SWT Planning Committee

Thursday, 5th January, 2023,
1.00 pm

5. **3/21/22/105 - Erection of ground mounted solar panels Avondale, Martlet Road, Minehead, TA24 5QD** (Pages 5 - 14)
6. **42/22/0043 - Variation of Condition No. 2 (approved plans), for the inclusion of a turning head at the entrance of the approved pumping station compound, of application 42/20/0042 at Orchard Grove New Community, Comeytrove Rise, Taunton** (Pages 15 - 114)

Application Details	
Application Reference Number:	42/22/0043
Application Type:	Section 73 – Variation of Condition
Description	Variation of Condition No. 02 (approved plans), for the inclusion of a turning head at the entrance of the approved pumping station compound, of application 42/20/0042 at Orchard Grove New Community, Comeytrove Rise, Taunton
Site Address:	Orchard Grove, Land off Comeytrove Lane, Taunton
Parish:	Trull
Conservation Area:	No
Somerset Levels and Moors RAMSAR Catchment area:	Yes
AONB:	No
Case Officer:	Simon Fox, Major Projects Officer (Planning) 07392 316159 s.fox@somersetwestandtaunton.gov.uk Should you wish to discuss the contents of this report item please use the contact details above by 5pm on the day before the meeting,

Figure 8.1 – Deficiencies in developer’s identified walking routes

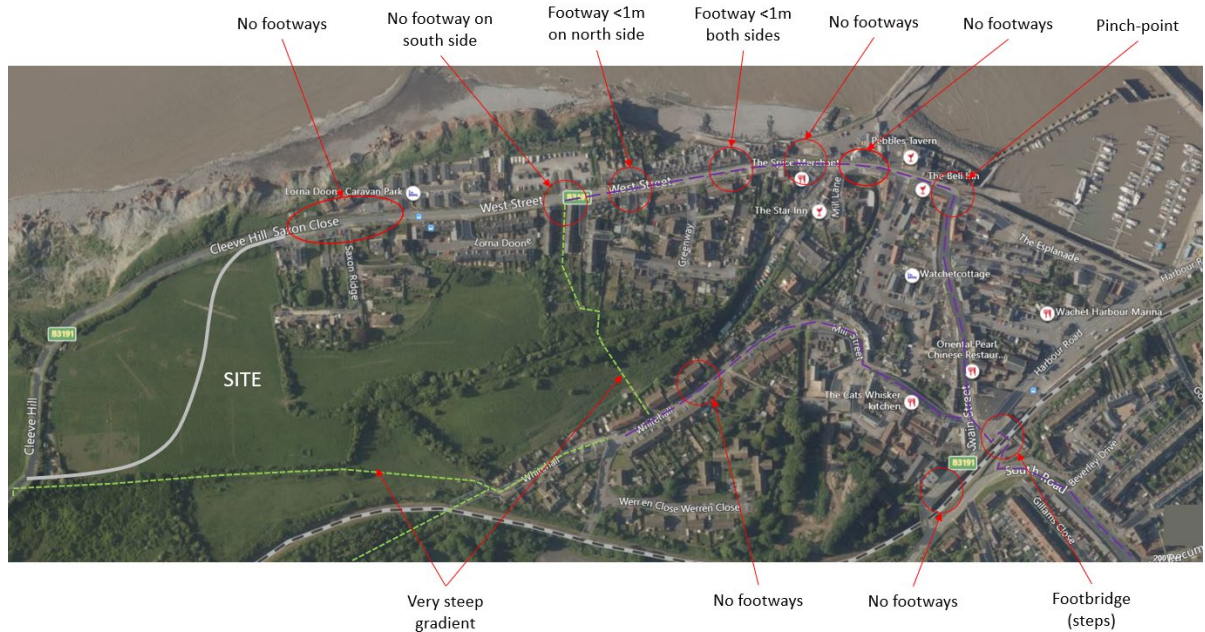
- 8.7. The submitted walking plan indicates new dropped kerbs and tactile paving at the junction with Greenway; however, the footways to the west of Greenway are extremely narrow on one or both sides of West Street. They are too narrow for two pedestrians to pass, thereby requiring one pedestrian to step into the carriageway. They are also too narrow for a pedestrian with a pushchair and certainly too narrow for a wheelchair or mobility scooter. This is clearly not a suitable walking route without significant mitigation.

8.8. Figure 8.1 illustrates the significant deficiencies in the suggested walking and cycling routes on the submitted ‘Route to school NMU plan’. This is not intended to be a comprehensive study of the condition of walking and cycling provision as that responsibility falls to the developer; however, it is clear that the developer has still failed to demonstrate that safe and suitable provision can be made for pedestrians and cyclists in accordance with TR1 and TR2.

Plate 1 – Extract of Stantec (2020) Figure 2

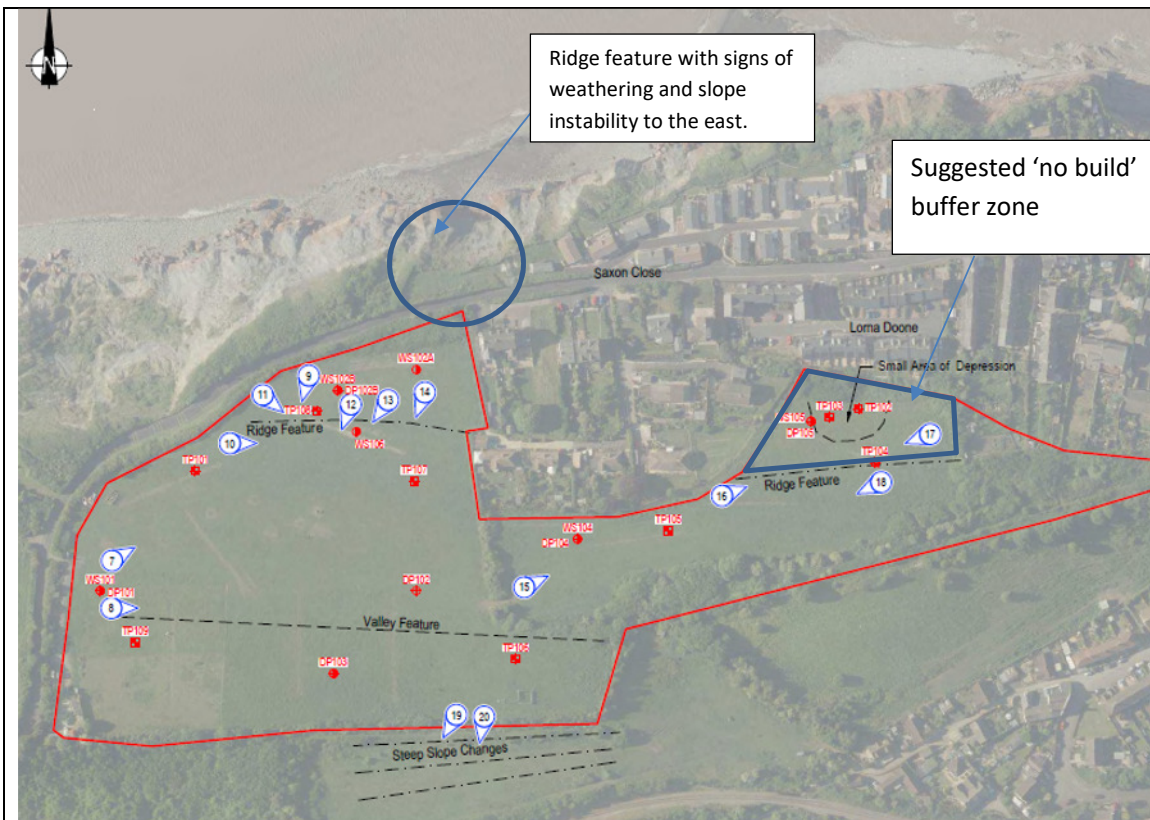
Also within this area, Stantec note a small arc with depression to the north of this ridge feature (Plate 1), to the south of Lorna Doone. The Stantec report states that the arc depression was investigated via two trial pits, which did not record any evidence to indicate that the ground is effected by ground movement

As such, no development should be permitted in this area. Fairhurst would therefore recommend if the planning application is granted permission, that a no build buffer zone is implemented beyond the geological ridge in this portion of the site, as indicated on Plate 1.
